TRURO ACTIVE TRANSPORTATION NETWORK REVIEW

Contact: Michael MacDonald, P.Eng.
Email: mmacdonald@harboursideengineering.ca
Phone: +1 902 405 4696
Date: 2025-Feb-18
File No. 242057

Truro Active Transportation Network Review

Figure 12: Kaulback Street, Proposed Cross Section

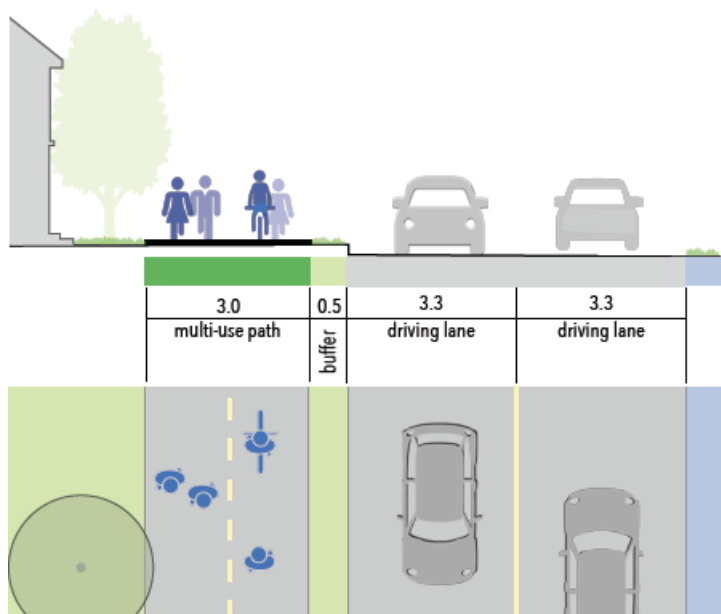
Figure 12 illustrates the proposed cross section on Kaulback Street. The existing sidewalk is removed and replaced with a 3.0-metre-wide multi-use pathway with buffer on the east side. While the report indicates that the multi-use pathway is to be provided on the east side, it does not take into account that the existing sidewalk transitions to the west side south of the Cobequid Trail. The additional space required for the new multi-use pathway is accommodated by reducing the vehicle lane widths to 3.3 metres.

Figure 15: Lorne Street Section A, Proposed Cross Section

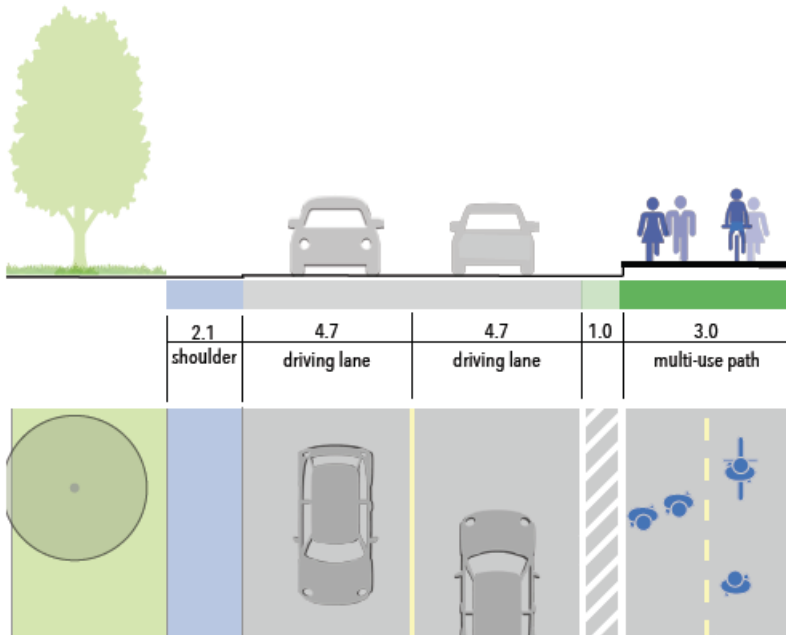
Figure 15 illustrates the proposed cross section on Lorne Street between North Street and Park Street (Section A). A 3.0-metre-wide multi-use pathway with buffer is provided. The report does not clearly indicate on which side of the road street the pathway is proposed in Section A. No changes are made to the vehicle lanes to accommodate the multi-use pathway.

Figure 18: Marshland Drive, Proposed Cross Section

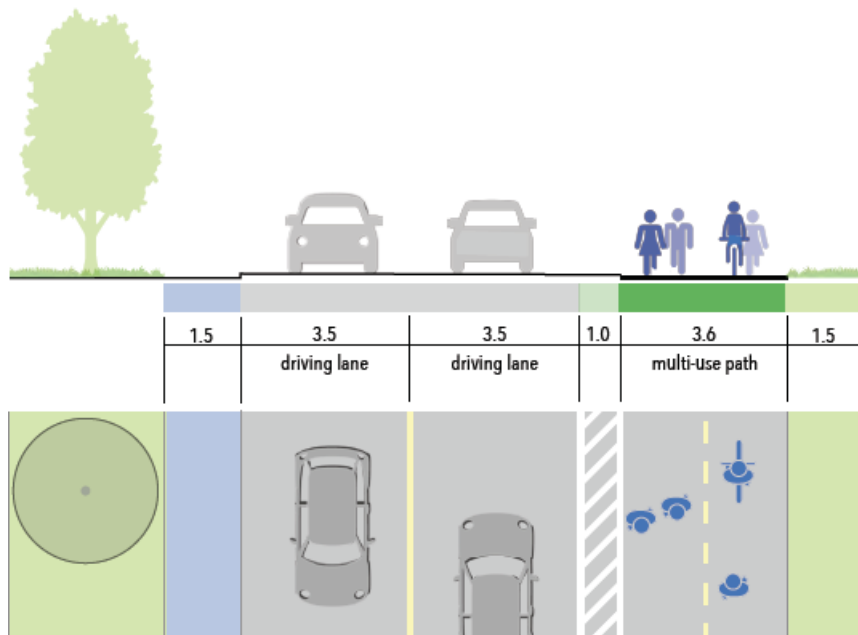
Figure 18 illustrates the proposed cross section on Marshland Drive. A multi-use pathway is provided on one side of Marshland Drive. While the report describes a 3.0-metre-wide pathway, the cross section illustrates a 3.6-metre-wide pathway. The report does not specify which on side of Marshland Drive the multi-pathway is proposed, however, it appears to be on south side of the street based on the additional space within the right-of-way illustrated in the existing cross section. The space required for the new multi-use pathway is accommodated by reducing the vehicle lane widths and eliminating the road shoulder.

Figure 38: Wade Road, Proposed Cross Section

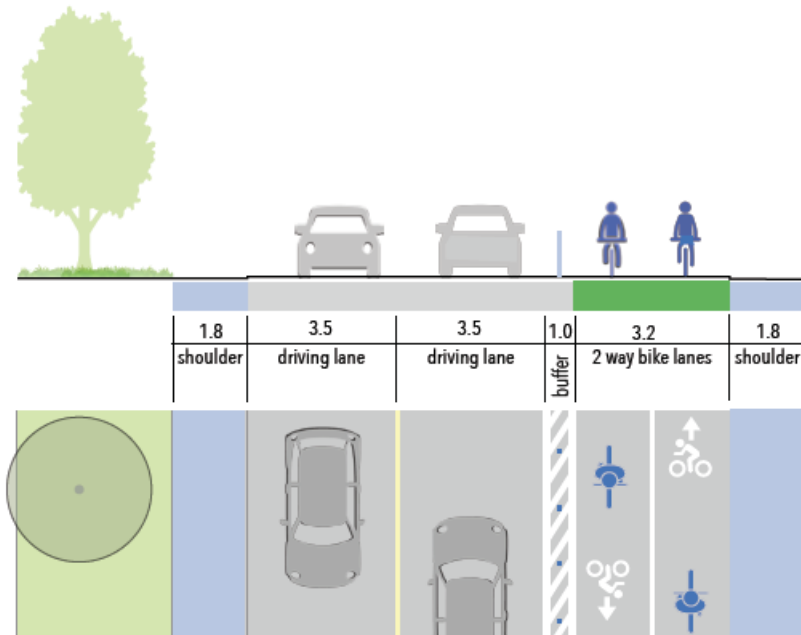
Figure 38 illustrates the proposed cross section on Wade Road. A 3.2-metre-wide bidirectional protected bikeway with a 1.0-metre-wide delineator is provided. The report does not specify on which side of Wade Road the protected bikeway is proposed; however, it is likely to be on east side of the street to minimize impacts to utility poles. The proposed cross section does not include any pedestrian facilities, however, while the cross section clearly illustrates bike lanes, the text in the report mentions a multi-use pathway. It is unclear if the cross section or description is correct.

Figure 45: Willow Street Section B, Existing Cross Section

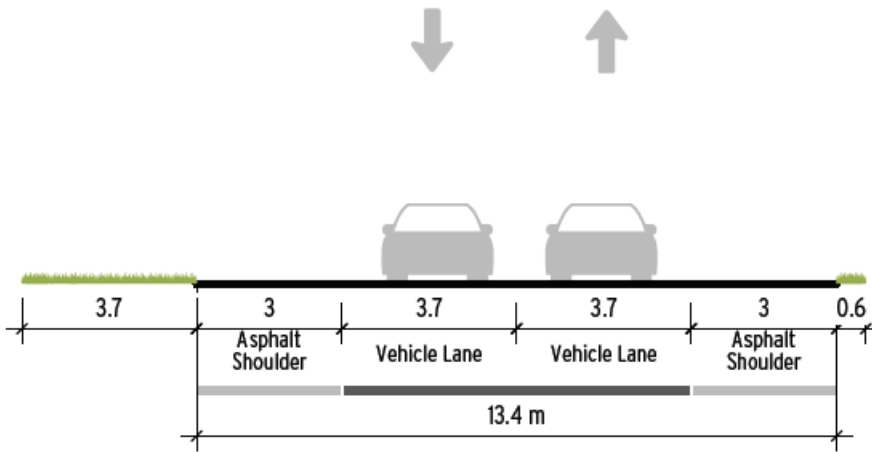
Figure 45 illustrates the existing cross section on Willow Street between Arthur Street and Millbrook (Section B). The cross section does not match actual conditions along the majority of the corridor. There is existing sidewalk on one or both sides of Willow Street between Arthur Street and Glenwood Drive, and on the west side between Blakeney Drive and Rachel Lane (Town boundary). The illustrated cross section with shoulders on both sides of the street is only observed between Glenwood Drive and Blakeney Drive (this was to William Barnhill Drive when the report was prepared in 2023 – new sidewalk has been installed since).
